From: "Erin Stagg" <erin@edgarplanning.co.nz>
Sent: Mon, 13 Apr 2026 13:56:14 +1200
To: "Vicki Jones" <vicki.jones@qldc.govt.nz>
Subject: FW: RM251085 - A & E Gray - s 95B assessment in regard to 16 Wanaka –Mount Aspiring Road
Attachments: 6778-Roys-Bay-Boatsheds-RC-260413.pdf

From: Vicki Jones <vicki.jones@qldc.govt.nz>
Date: Thursday, 26 March 2026 at 2:00 pm
To: Erin Stagg <erin@edgarplanning.co.nz>
Subject: RM251085 - A & E Gray - s 95B assessment in regard to 16 Wanaka –Mount Aspiring Road

ROYS BAY BOATSHEDS
20 WANAKA - MOUNT ASPIRING ROAD • WANAKA

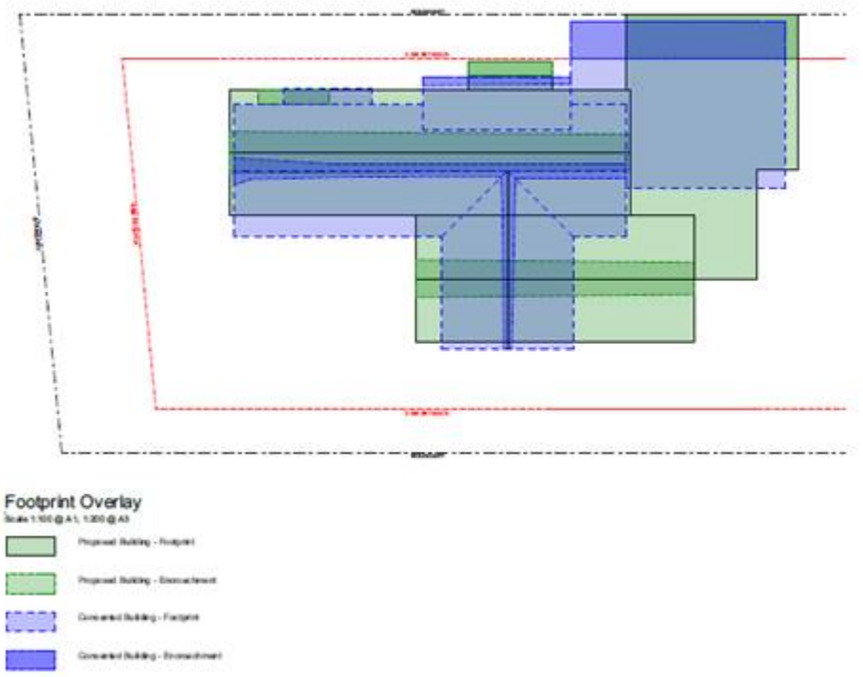
I see the barn now encroaches into the southern boundary whereas it did not in the earlier plans (which the AEE relies on) and will no longer necessarily be plaster. I will need to update the decision to reflect that change. There are no other changes that have occurred in the 11th hour that I may have missed are there?

As for the plans, it is possible to have WM create an updated version of the below plan as I had relied on including that in the body of the decision as it makes the change between the consented and proposed footprints and height encroachments really clear (much clearer than I can do in words probably). In the meantime I will finish of the decision and have it ready to go to the decision maker as soon as I receive an updated of the below

Please find, attached, a full plan set with the comparison plan. Luke has shifted the garage 500mm but I did not view that as a material change to the plans. Let me know if you think otherwise.

Find attached plan update with minor garage adjustment, and comparison plan included.

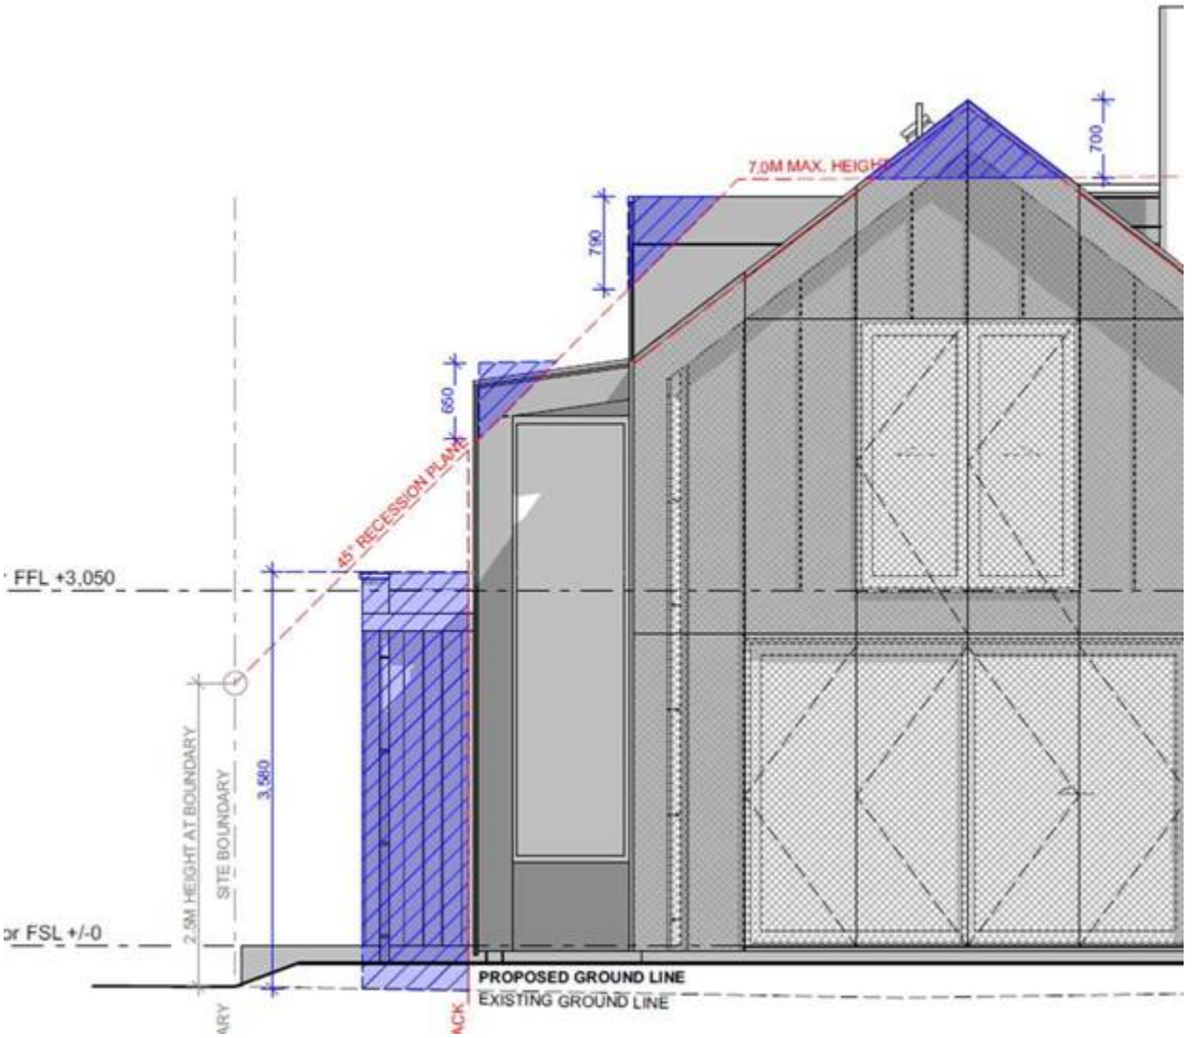
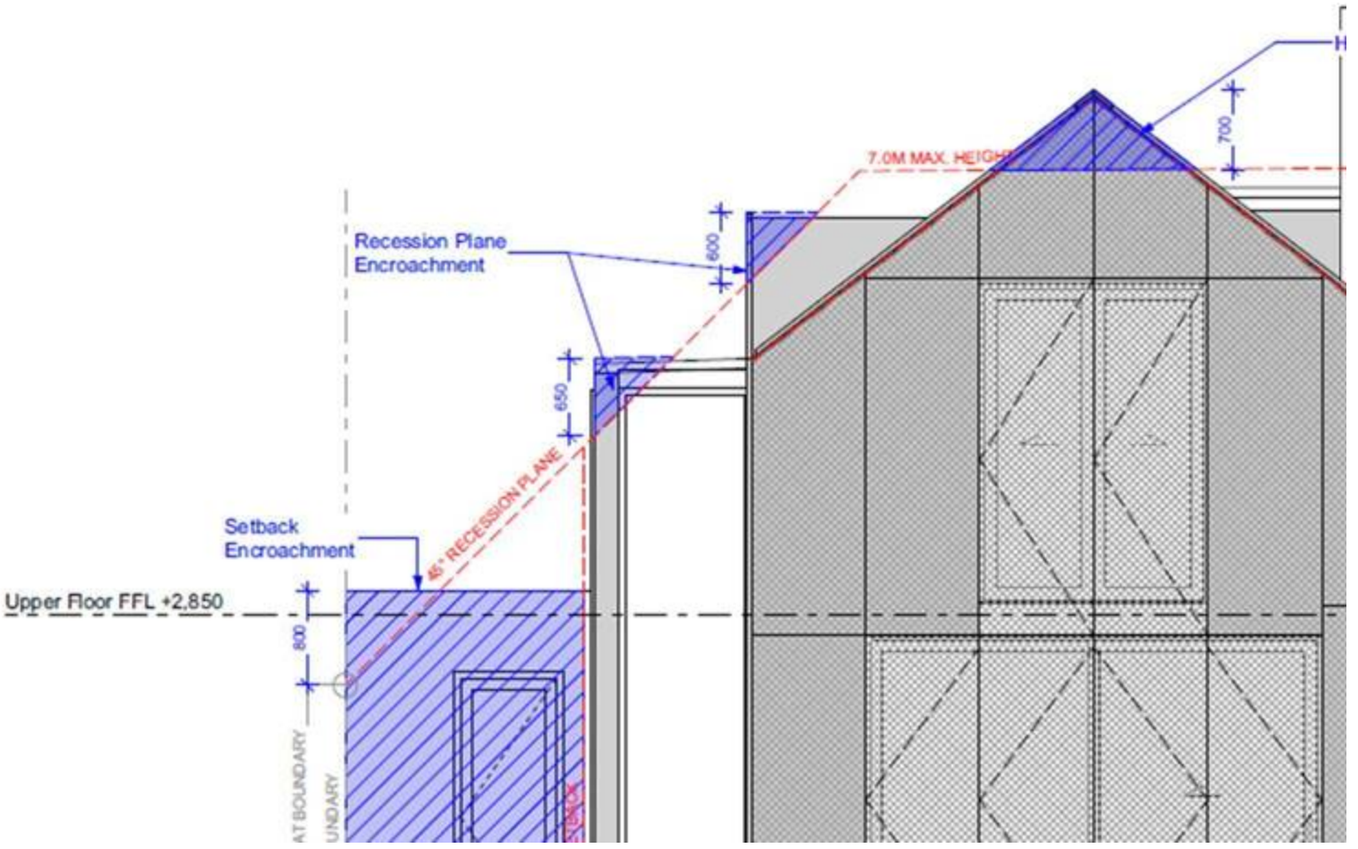
I have not thought this through fully yet but I am not convinced it will reduce the effects to less than minor, especially given that the rear barn already intrudes 2.7m through the recession plane (so there are some cumulative effects here to consider)

The garage re-design will undoubtedly have less visual effects on the neighbour although it is noted that it now has a window facing the neighbour and includes a laundry, meaning that less reliance can be placed on the permitted baseline for accessory buildings in the PDP and that a new issue of privacy is now raised. That said, given it is a laundry it may well be that the effect of the window is more than minor.

Comparing the plans (as inserted below), I note that the new plans now include more encroachment through the recession planes than in the plans that were lodged earlier (while the increase in height encroachment is relatively minor (190 mm) the increase still adds to the overall extent of bulk form in close proximity to the neighbour (i.e. approximately 5m2 of the elevation is through the recession plane wheras its approximately 1.4 m2 in the currently consented plans).

I am curious to know if the applicant has considered what it would do to the extent of encroachments if the building is moved 0.5 m west on the property? Without the benefit of plans showing that and with only limited measuring tools I can't assess it in any detail but it seems that it would make a considerable difference to the encroachments and the effect on # 16 without resulting in

any new non compliances on the western elevation or interfering with the driveway or future boundary planting. Please let me know if that is something that has, or could possibly be, considered.

- The garage window has been removed; and
- The dormer and associated height recession plane breach has been removed.

Please see, attached, the updated plans. The garage has been moved further from the setback and shortened to 7.63m. It will be clad in cedar.

You will also note that the architects have returned the pop-out portion of the building to the metal cladding.
